Client	Willmott Dixon Construction			
Project	University of Lincoln Centre of Excellence			
Drawing Title	Proposed Sections (Planning)			
Suitability Status	S2 - Suitable for Information			
Job No.	Scale	Size	Rev	
190747	1 : 100	@ A1	P02	
Drawing Number	M00439 - PEV - V1 - ZZ - DR - A - 9006			
Client Code	Originator	Zone	Level	Type
				Role
				Number

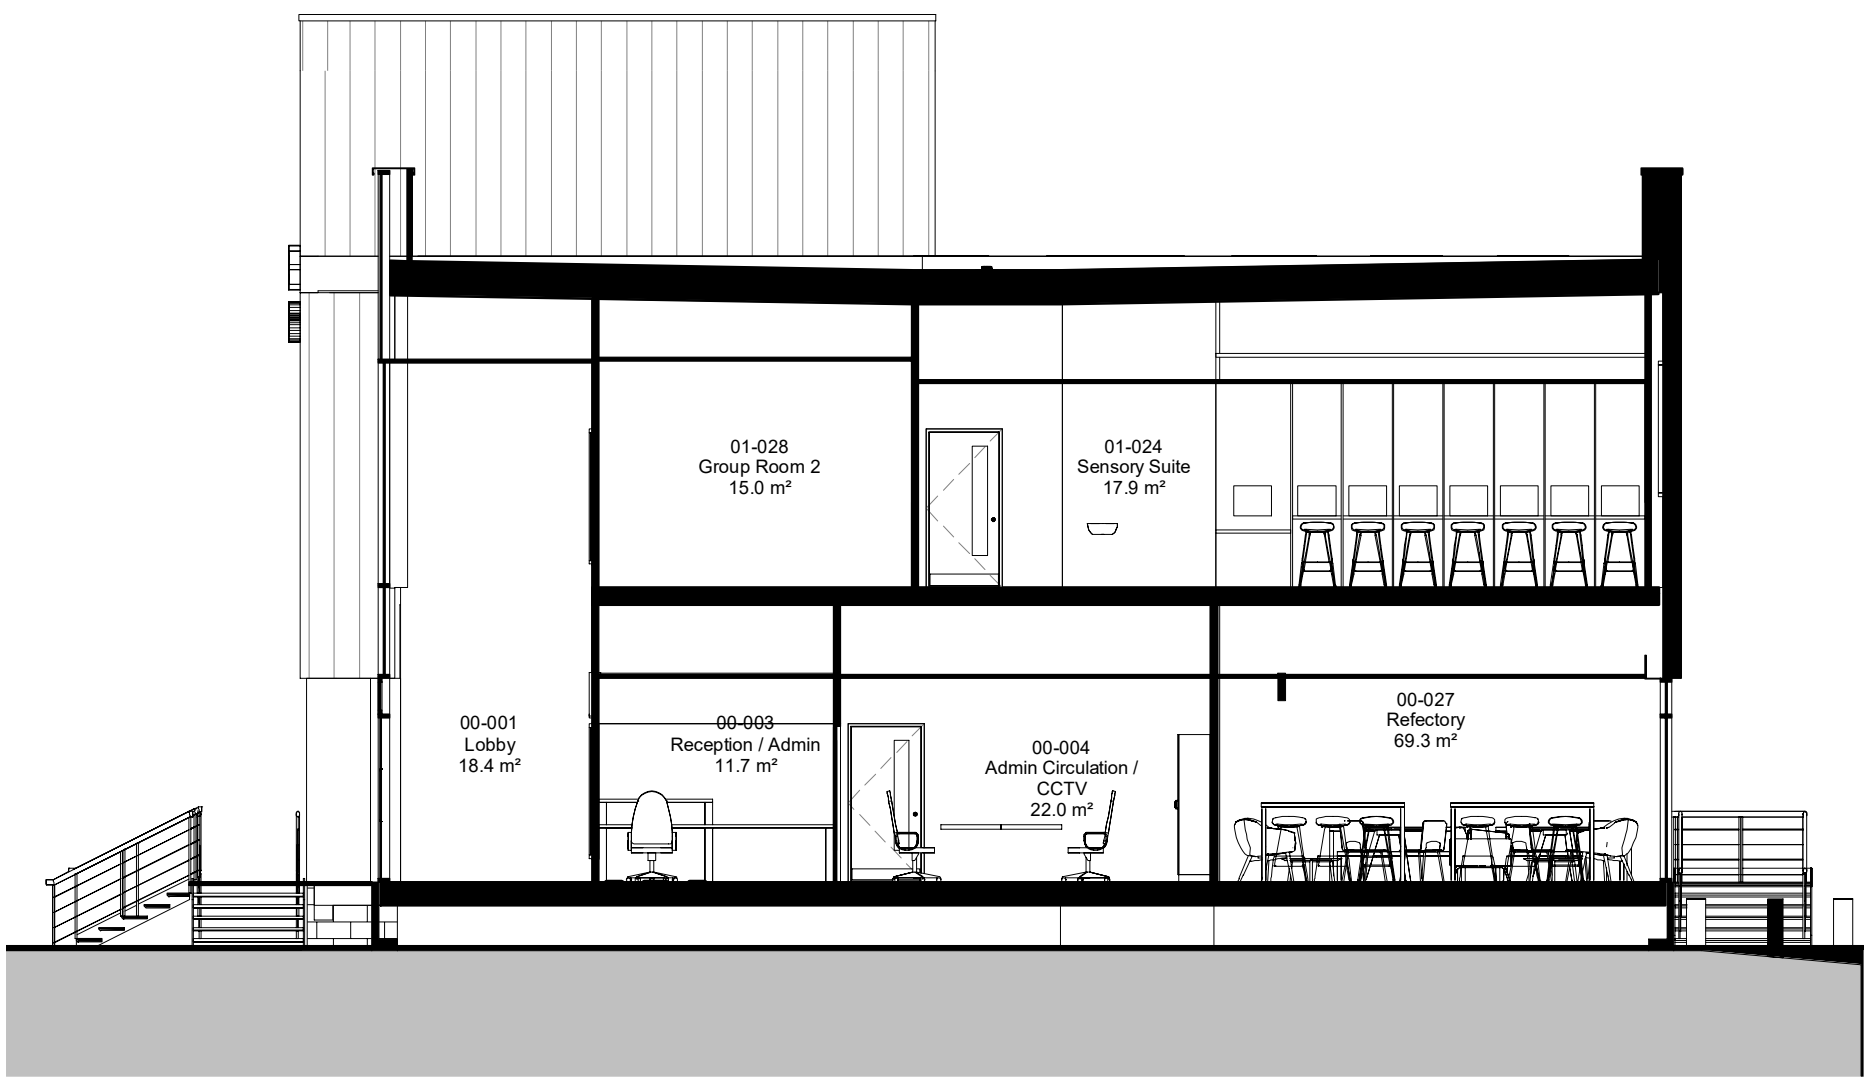
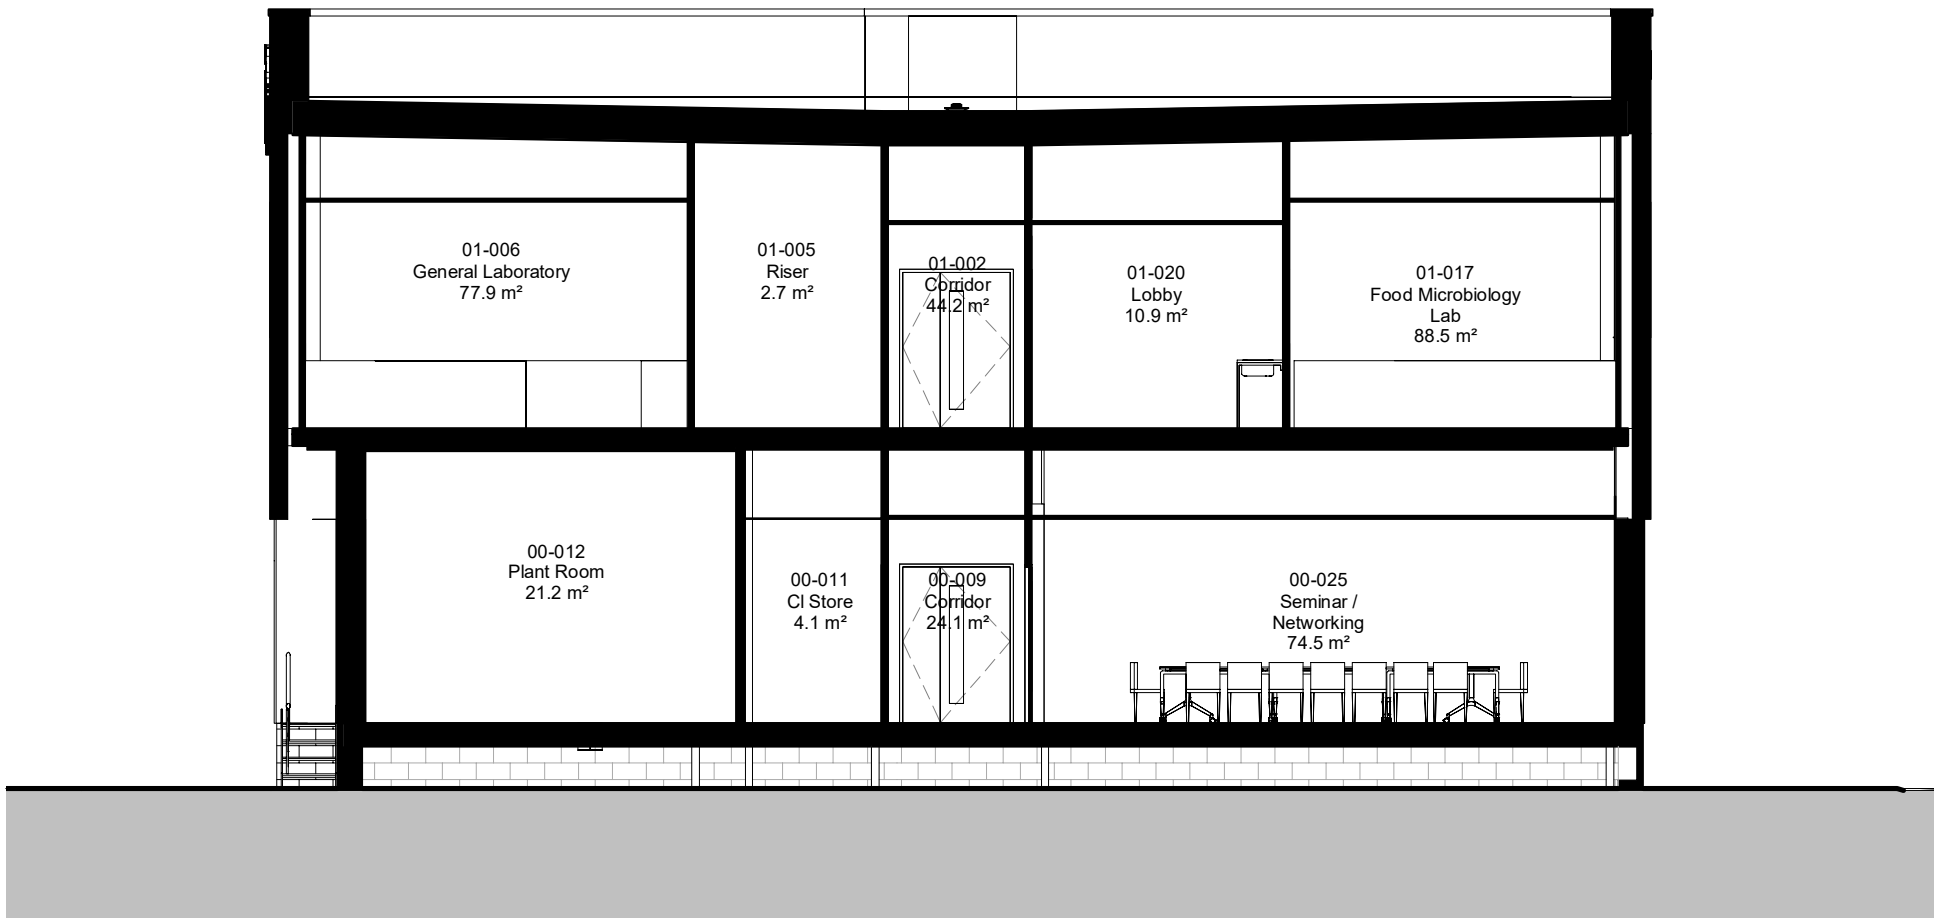
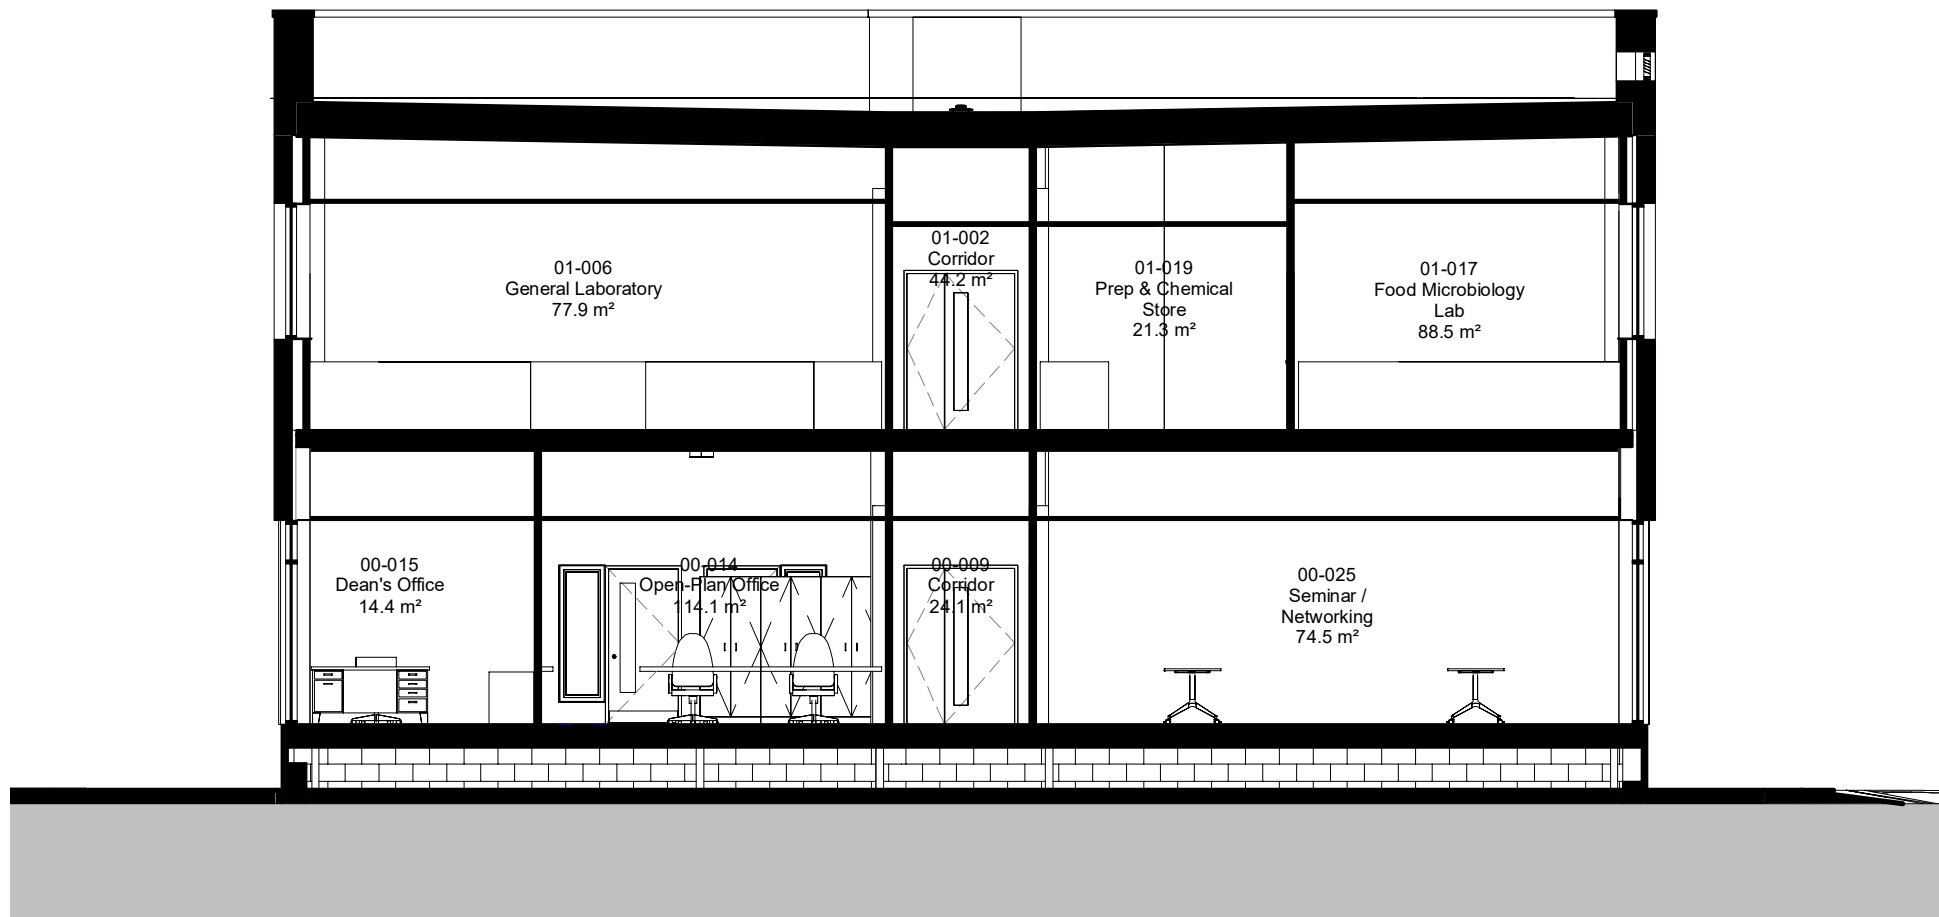
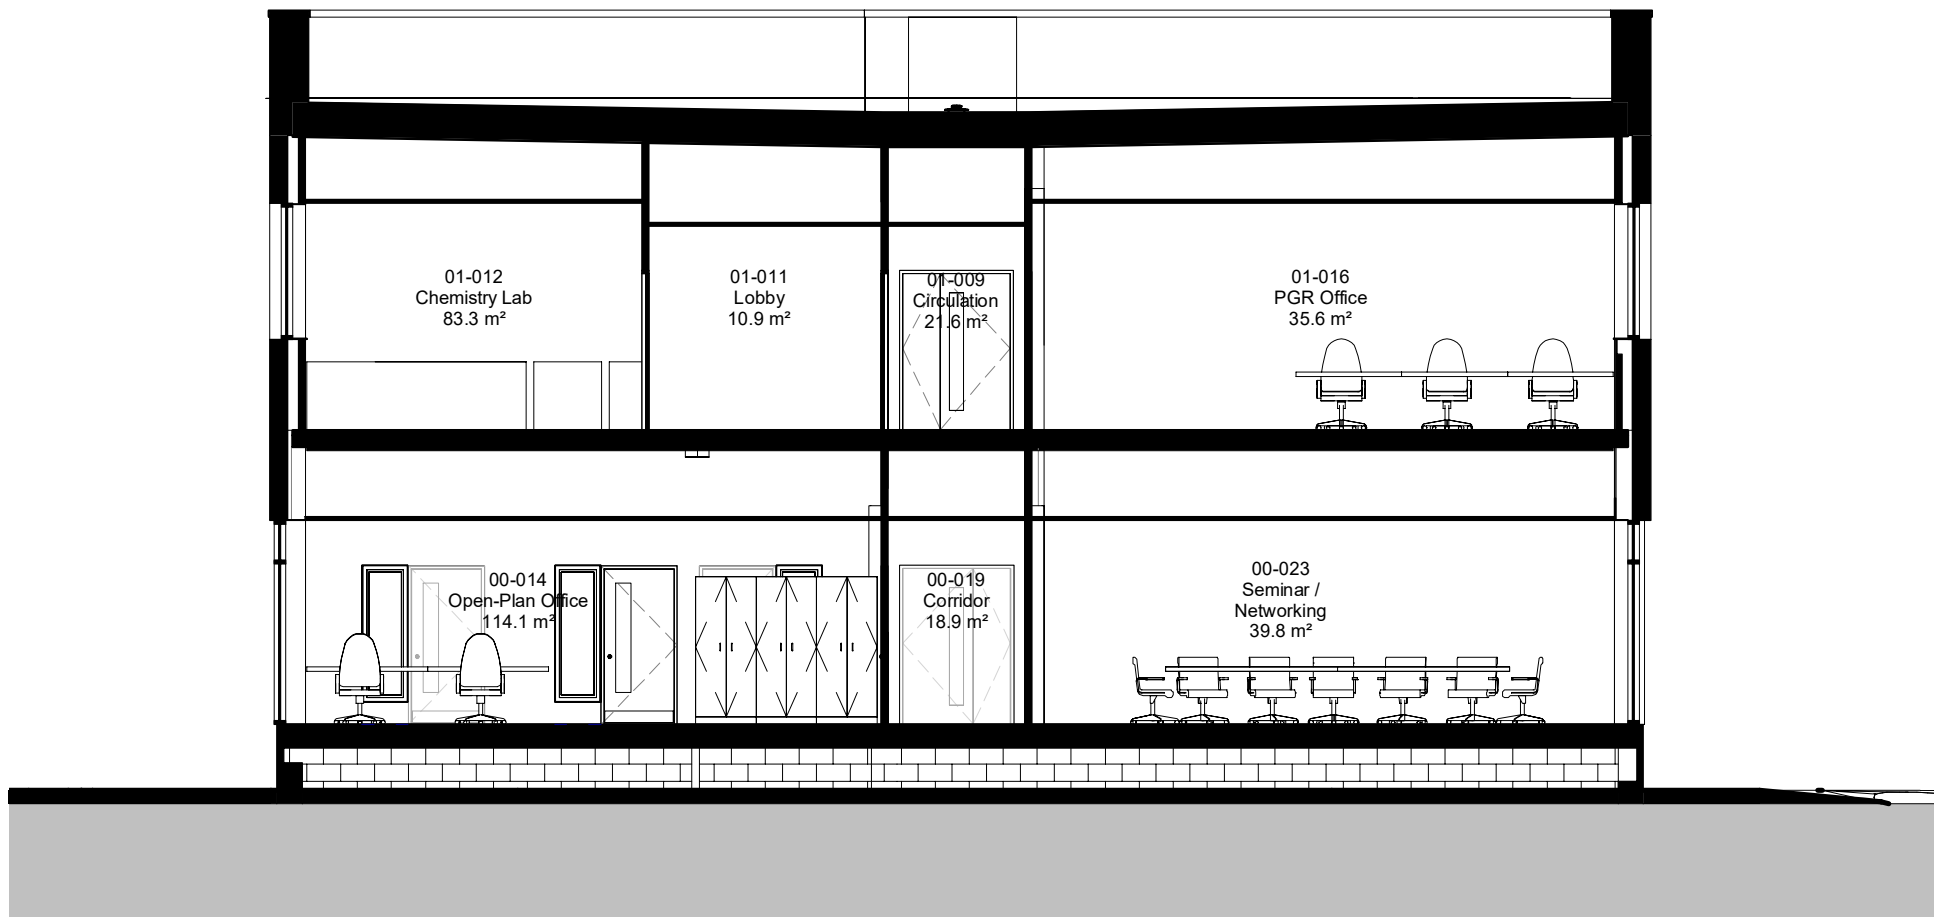
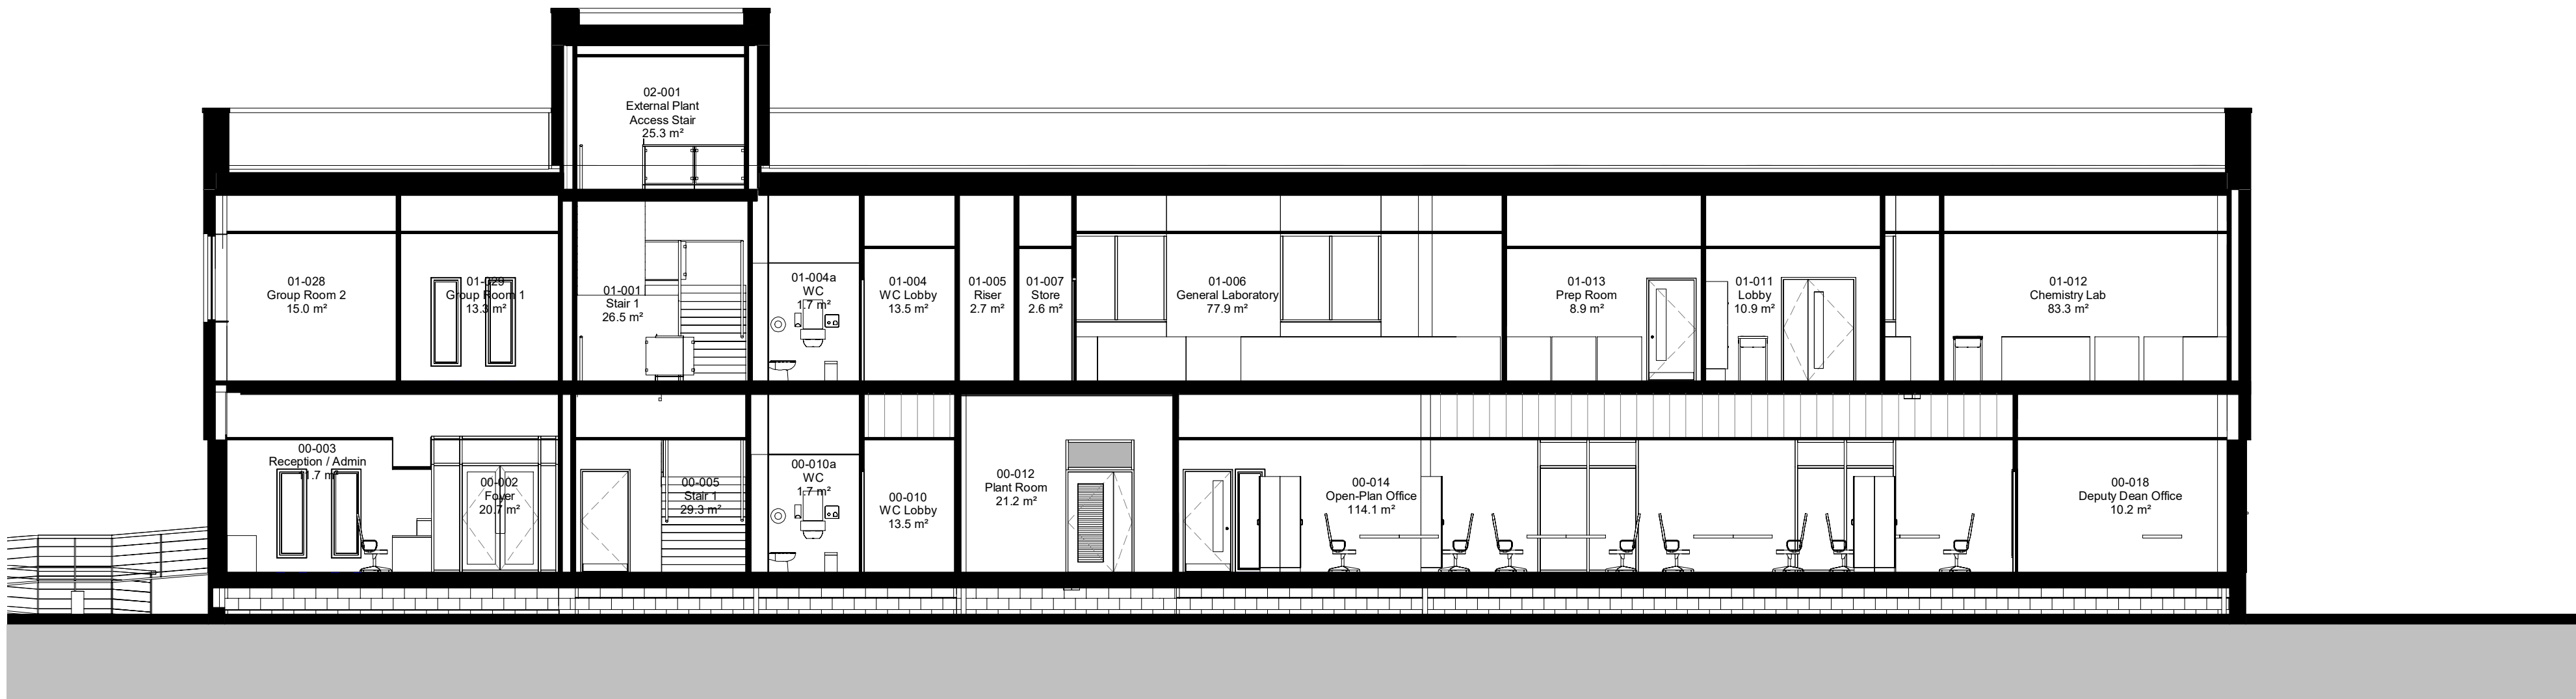
P02	Timber cladding and timber plant roof enclosure omitted/ building overall length reduced/ Extent of curtain walling reduced/ Submitted for Planning approval	29.08.19	PAH	DPA
P01	Issued for Planning	29.02.18	RJT	DMS
Revision		Date	Dn	Chk
This document references the following files:				
Reference Name	Status	Revision		
M00439-01-22-W3-A-0001	S1	P03
